Planning Commission
Meeting
05-01-17
Item
4.A.

Supplemental Commission Agenda Report

Subject: Malibu Memorial Park Project – Initial Study No. 16-002 and Mitigated Negative Declaration No. 16-001, Coastal Development Permit No. 15-028, Variance No. 16-016, Site Plan Review No. 16-009, Minor Modification No. 16-010, Conditional Use Permit No. 15-011, Lot Merger No 16-001 for construction of a new memorial park and chapel and associated development (Continued from April 17, 2017)

Conceptual Pacific Coast Highway Right Turn Lane Slope Plan
dated April 17, 2017

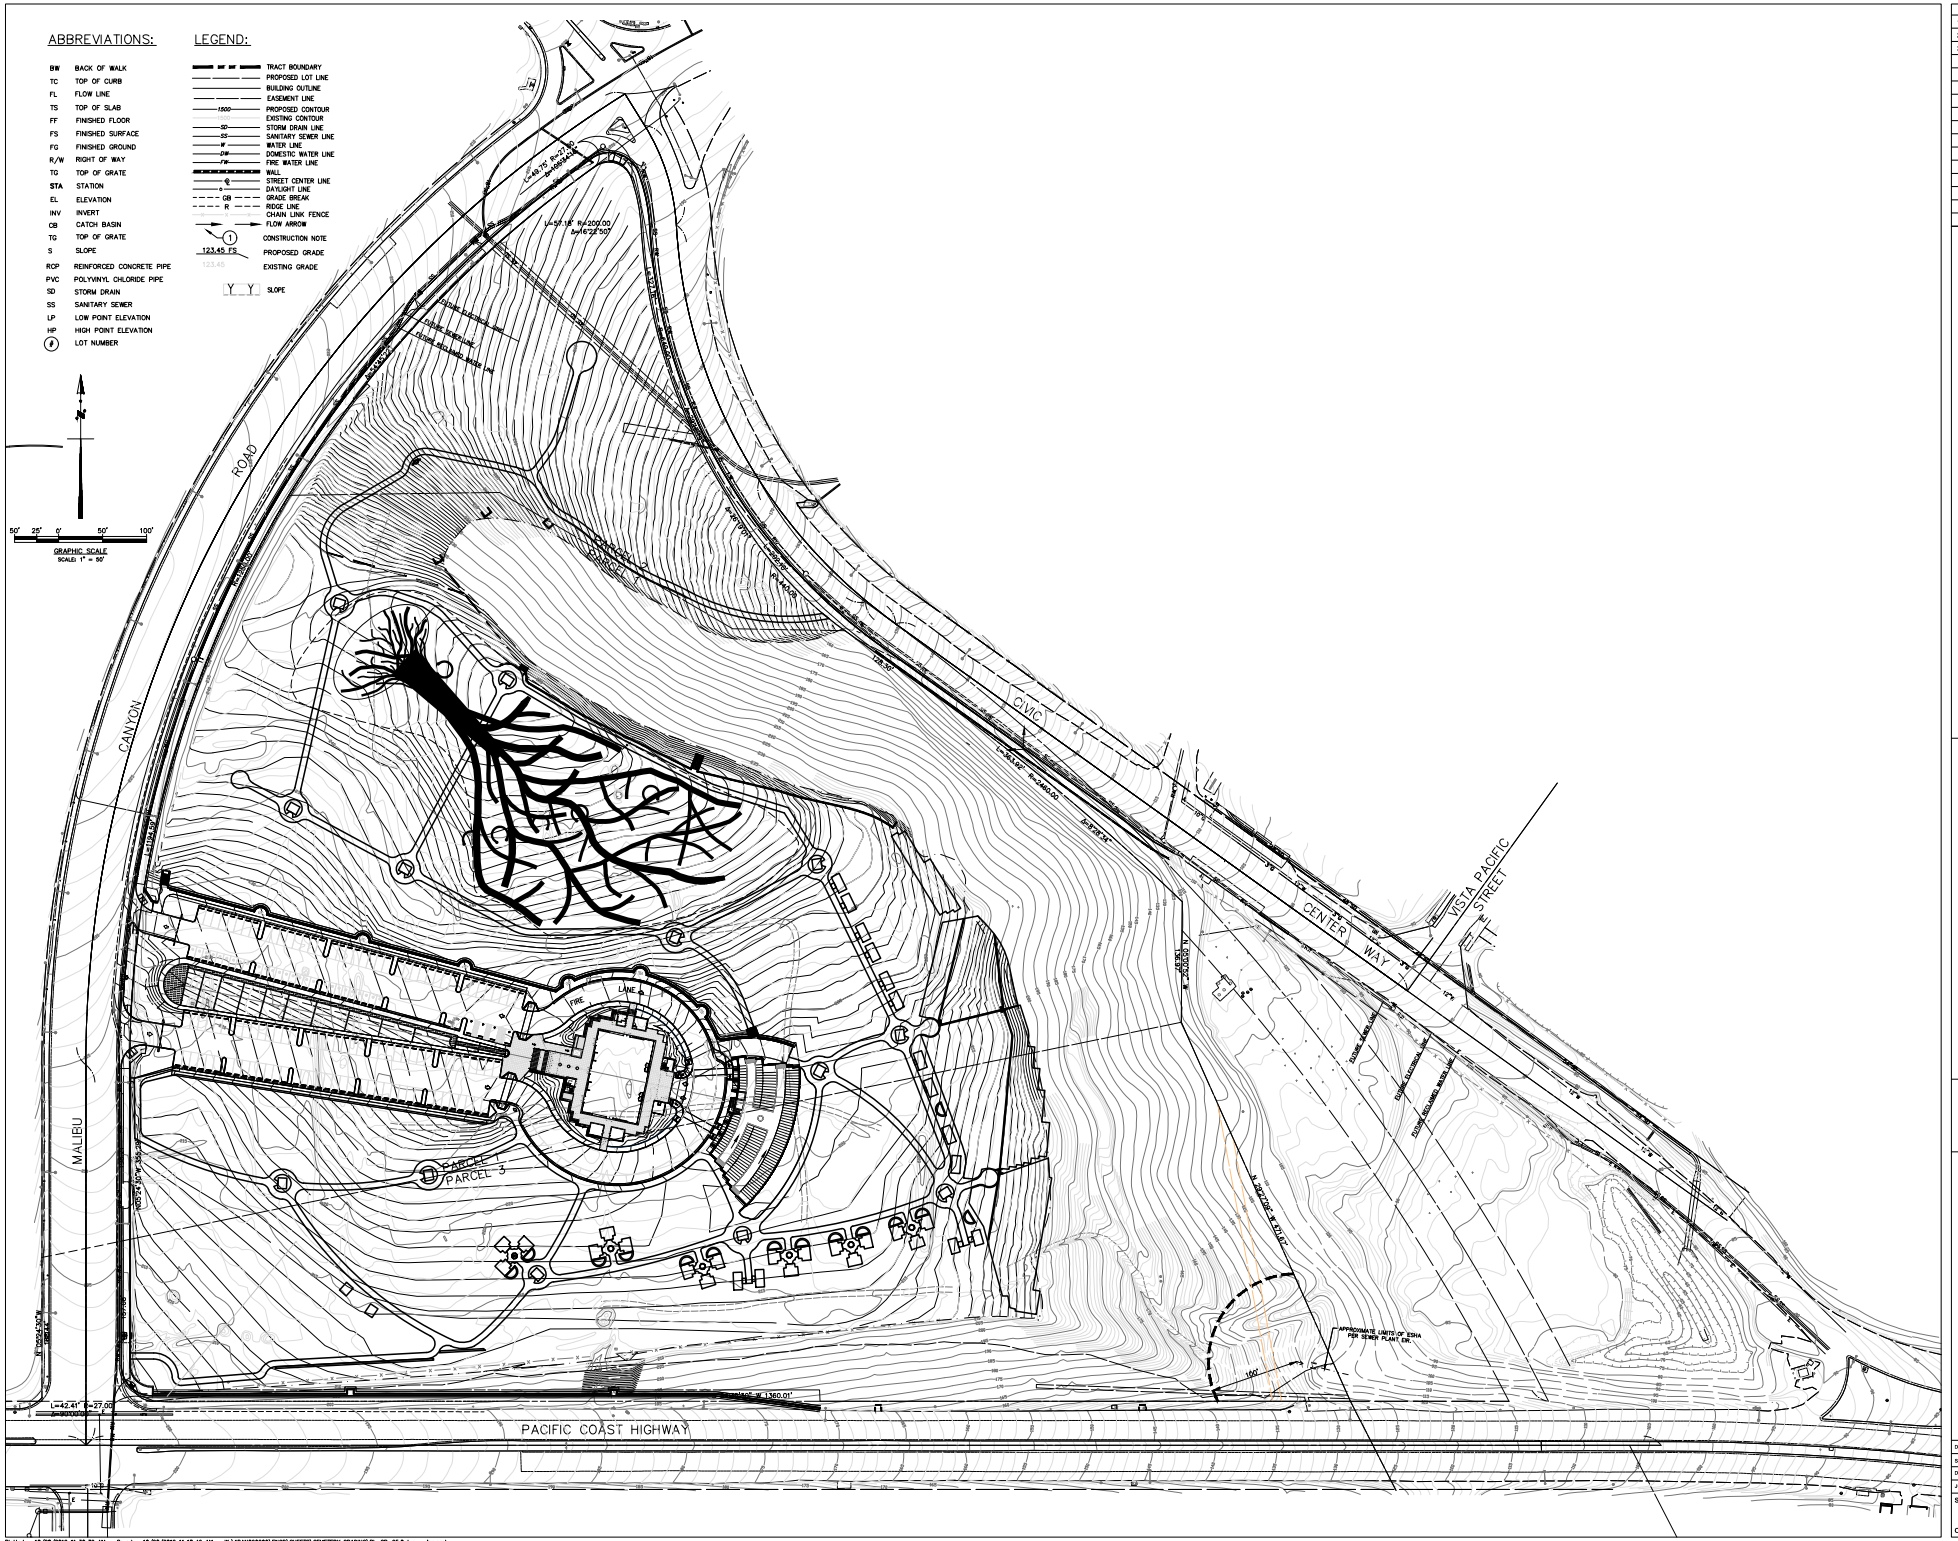
The project will improve the westbound right turn lane on Pacific Coast Highway which will affect the adjacent steep slope within the property. The applicant's grading plan included a retaining wall up to 15 feet in height constructed on the steep slope, which would necessitate a variance for an overheight retaining wall and a variance for construction on slopes steeper than 2.5 to 1.[1] The applicant has not applied for these variances. During the April 17, 2017, hearing, the applicant presented an alternative design for the lane improvement that was intended to avoid the need for the variances. The Commission directed staff to evaluate the viability of the design, the changes it would trigger in the grading quantities, and whether variances would be required.

The conceptual plan is included as Exhibit C. This design cuts the steep slope back to a transition slope no steeper than 2 to 1 (horizontal to vertical) and places a six-foot tall retaining wall at the top of the slope where the topography is flat. Because the top of the slope would move landward into the project site, the structure setback in this area would be adjusted landward accordingly, depending on the final dedication of property required by Caltrans. Some burial plots would be eliminated to accommodate the transition slope, and pathways and mausoleums would be resited landward as needed. The transition slope would be vegetated with native plants for erosion control.

The Public Works Department reviewed the conceptual design and determined it would be feasible to meet Caltrans and Malibu Local Coastal Program (LCP) requirements. The line of sight diagrams included on the conceptual plan indicate the mausoleums along this property boundary would not be visible to travelers passing on Pacific Coast Highway adjacent to the site. The native planting on the slope is expected to reduce the visual impacts of the lane improvement compared to the original design by maintaining the existing view of a planted slope instead of a tall retaining wall. Conditions of approval have been included in the resolution that require that the site plans and grading plans be revised for LCP consistency review and approval prior to plan check submittal.

The new slope design has also been evaluated for changes to the project grading quantities. The new design is estimated to add approximately 10,000 cubic yards of non-exempt cut material to the project totals. Since a grading variance is already included in the project entitlements, a new variance is not required. An updated grading conformance evaluation is included in the LCP Conformance section later in this report.

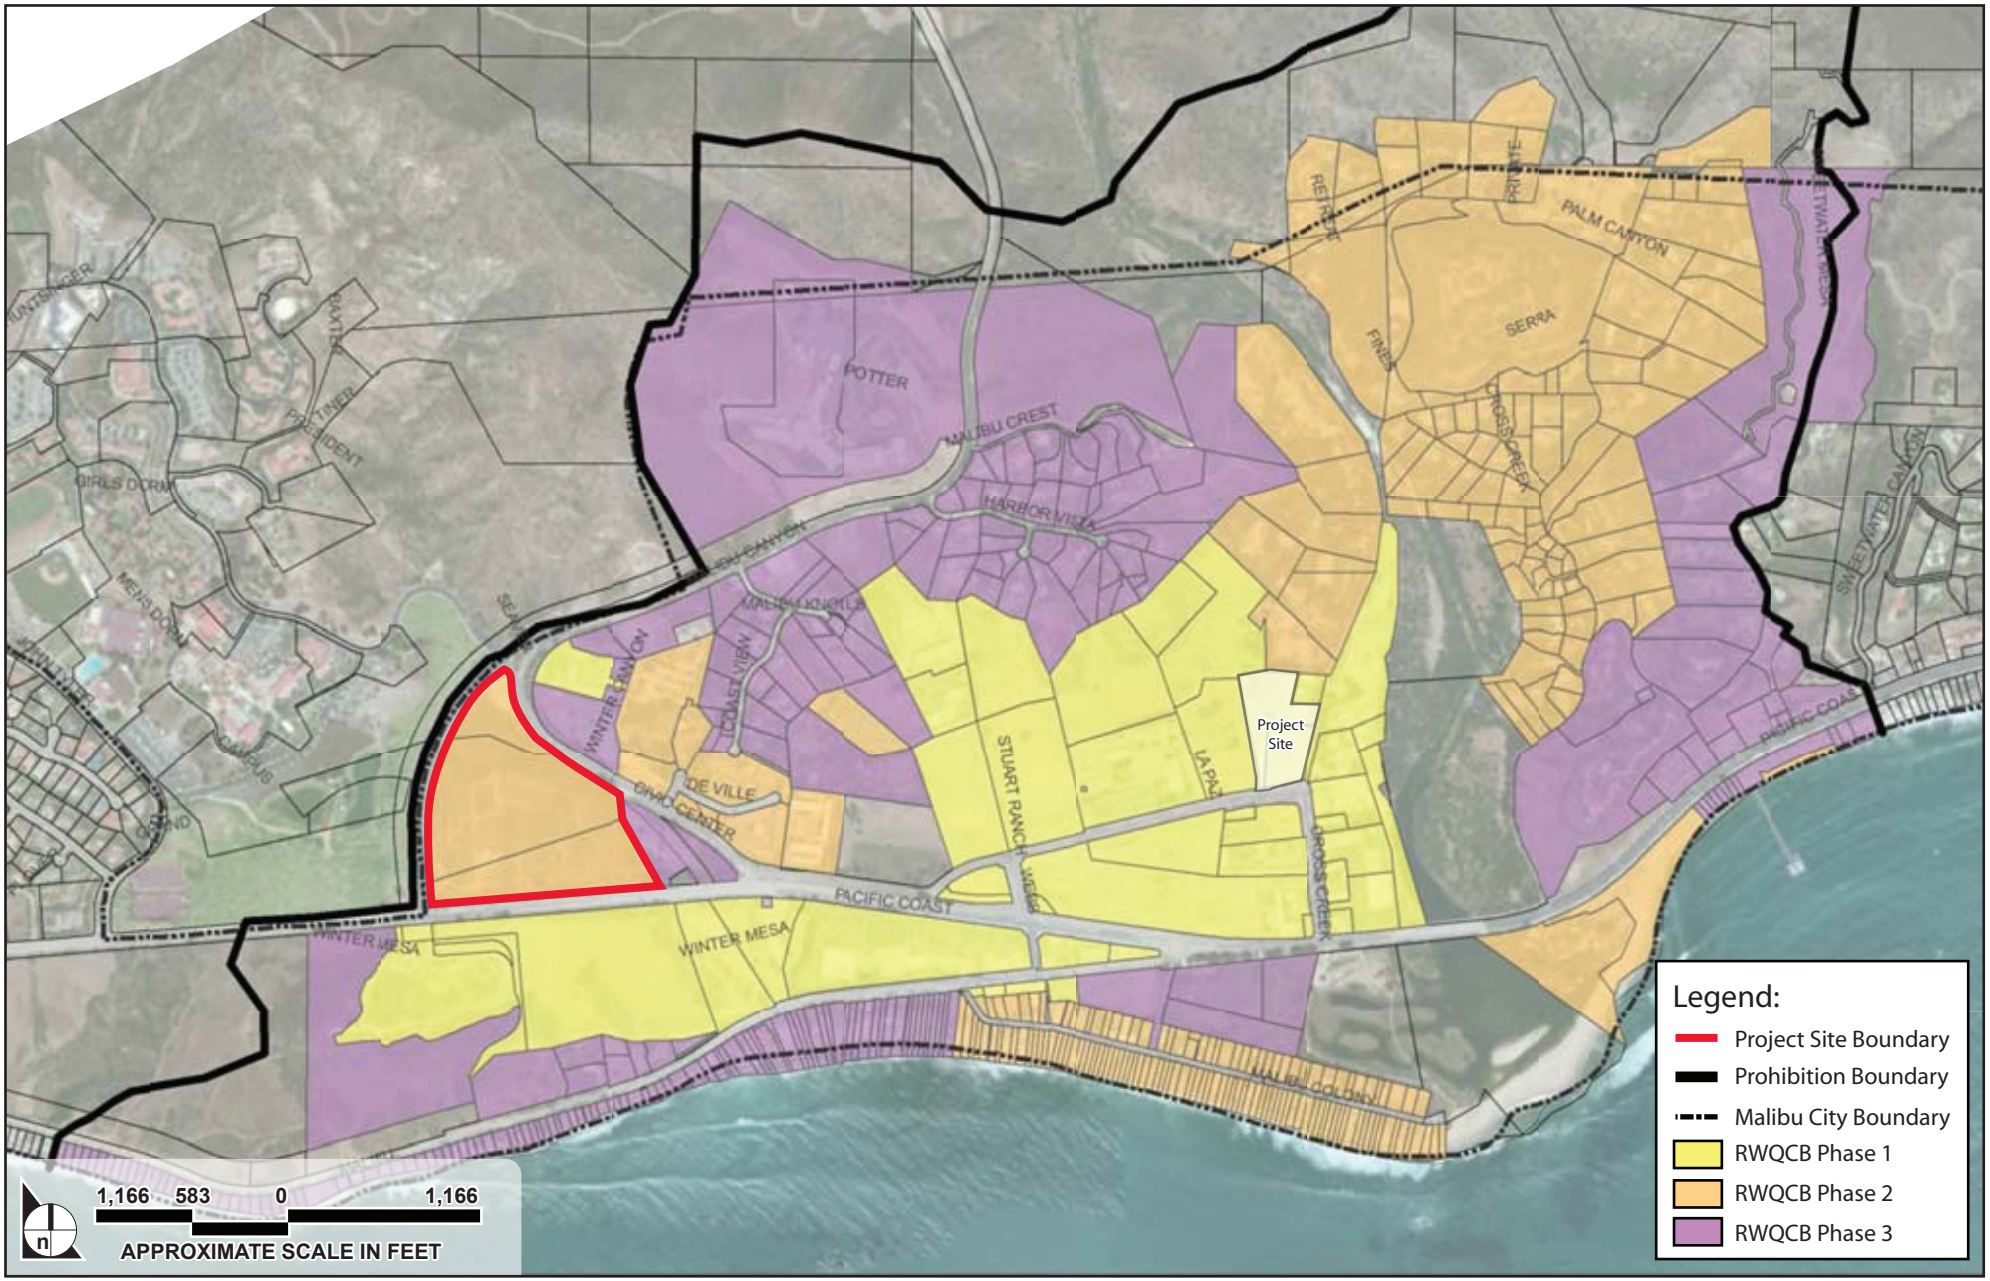
went into effect on December 23, 2010, for the Malibu Civic Center Area. The amendment (Resolution No. R4-2009-007) was adopted by the RWQCB and ratified by the State Water Resources Control Board (SWRCB) (Resolution No. 2010-0045) to institute a prohibition on new and existing discharges from OWTS in the Malibu Civic Center Area (Prohibition). The Prohibition applies to the "Malibu Civic Center Area," defined as portions of the lower Winter Canyon watershed, Malibu Valley watershed and adjacent coastal strips between and including Amarillo Beach and Surfrider Beach, and also known as the Prohibition Zone (Refer to **Figure 14, Prohibition Zone**).

Figure 14, Prohibition Zone on page 147 has been revised to delete the misplaced "Project Site" label.

Project Site and Surrounding Land Uses

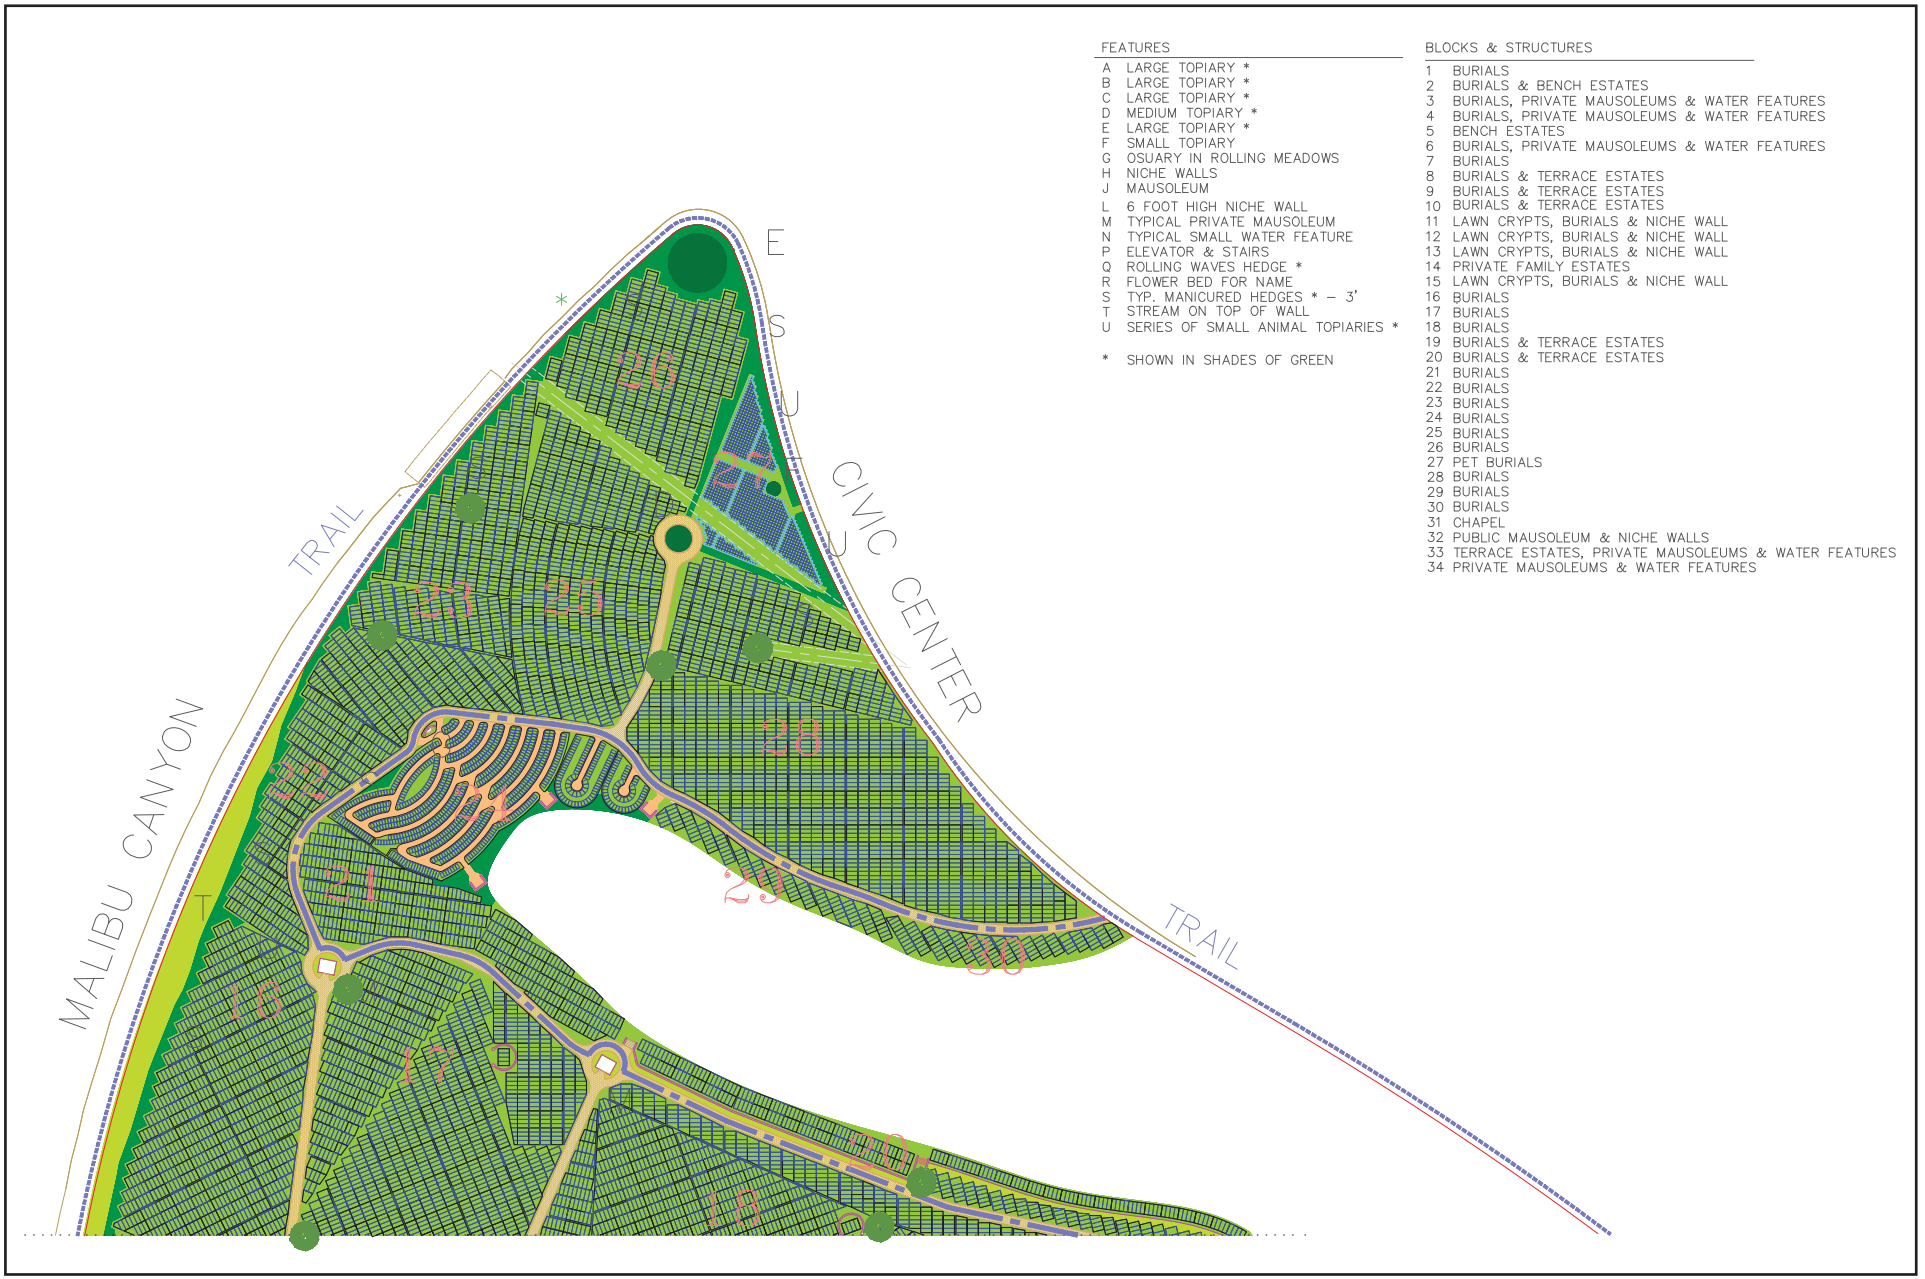
- **Page 15, Figure 3:** The Proposed Project Landscape Plan has been revised and updated. 10
- **Page 18, Figure 6:** There is a typo in the key – "Educational Facilities" is misspelled. Please correct. 11

Figure 6, Project Site and Surrounding Land Uses on page 18 has been revised to correct the word "Educational."
